RE: TIP SEDIMENT CORING PROGRAM – SAMPLING AND ANALYSIS PLAN

GENERAL ELECTRIC COMPANY - HUDSON RIVER PROJECT
TIP SEDIMENT CORING PROGRAM
FIELD SAMPLING PLAN ADDENDUM

Thompson Island Pool Sediment Coring Program

FIGURE A1-1.
Sampling Locations for
Extension to the Focused
Sediment Program

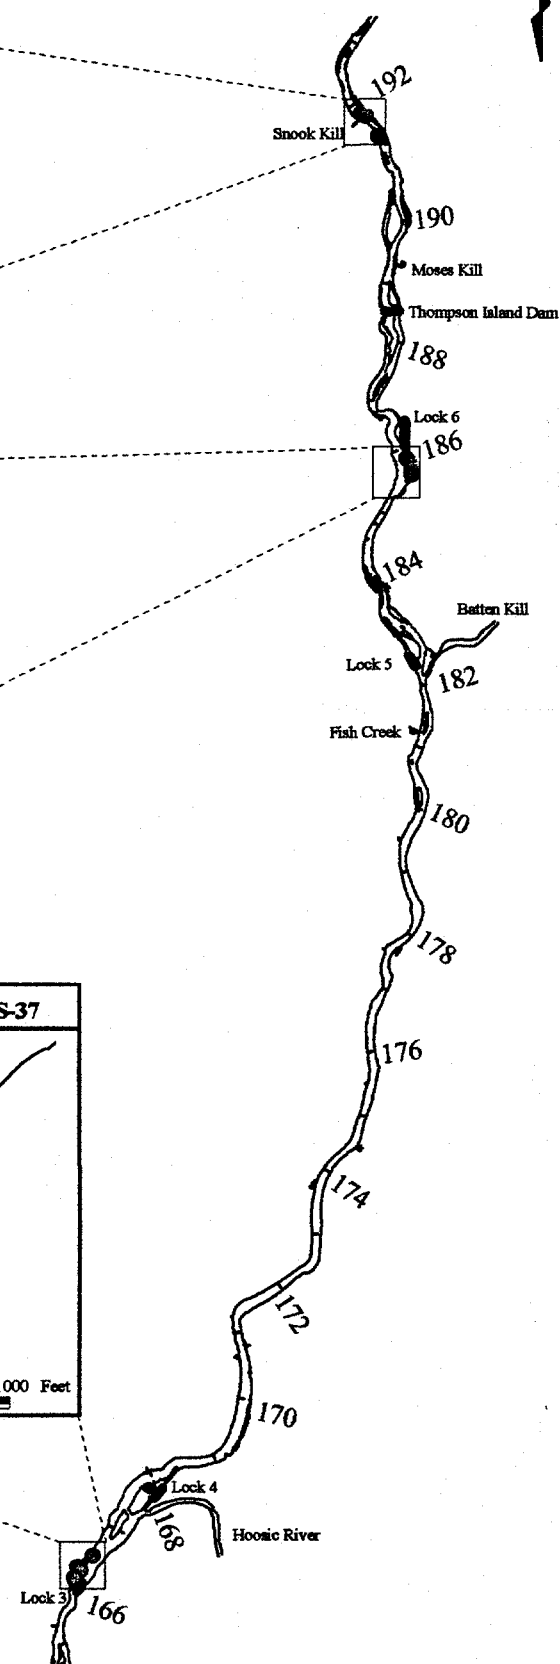
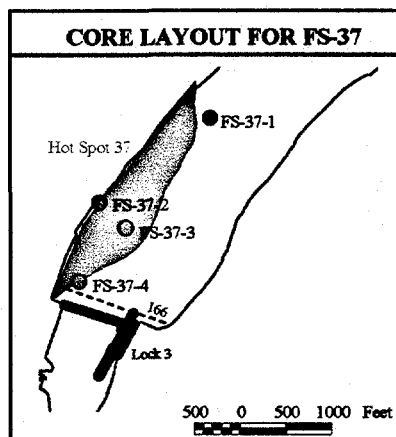
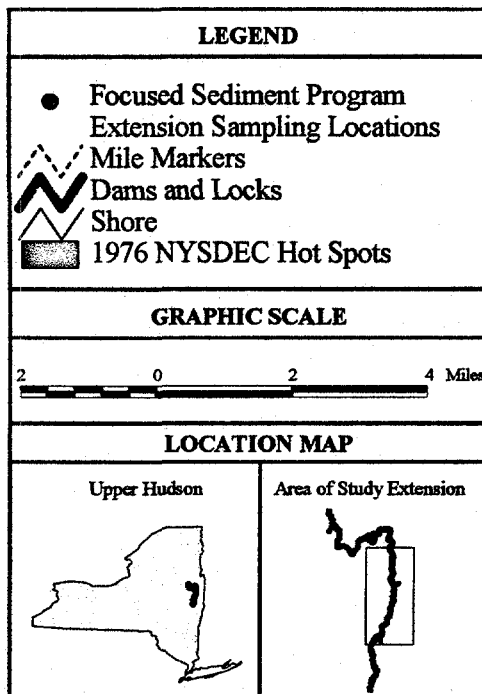
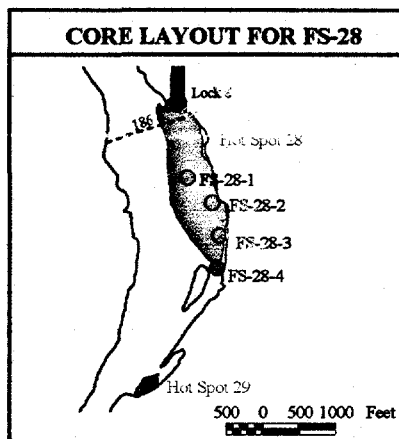
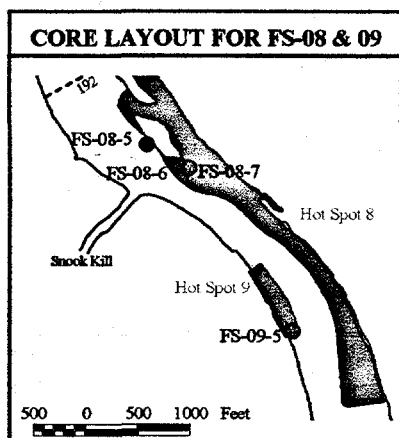
Core samples will be collected from 12 additional locations in the upper Hudson River. These locations will be consistent with sampling locations utilized by the USEPA in 1994, and are listed in Table A1-1. Target coordinate locations are presented in Table A1-2. Approximate sampling locations are illustrated in Figure A1-1.
